ADA Curb Ramp New Construction Inspection Form (Perpendicular)

24952.54

Turel

PERPENDICULAR RAMP (PR)

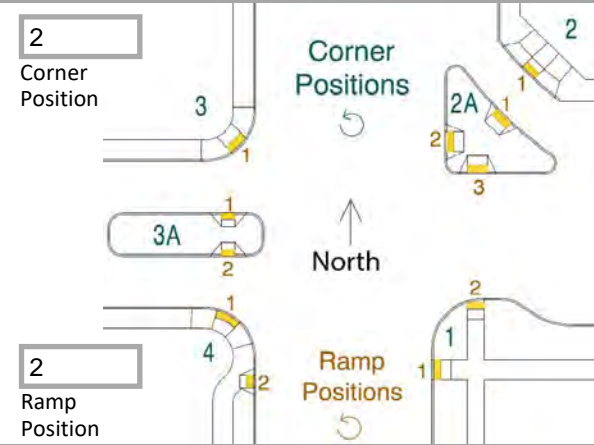
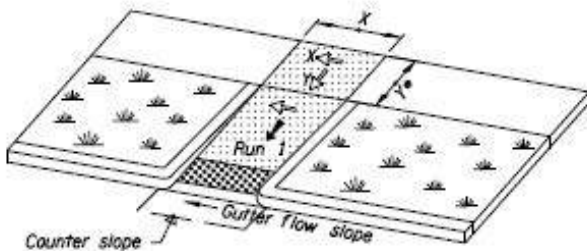
TS hump due to craftsmanship NE CORNER
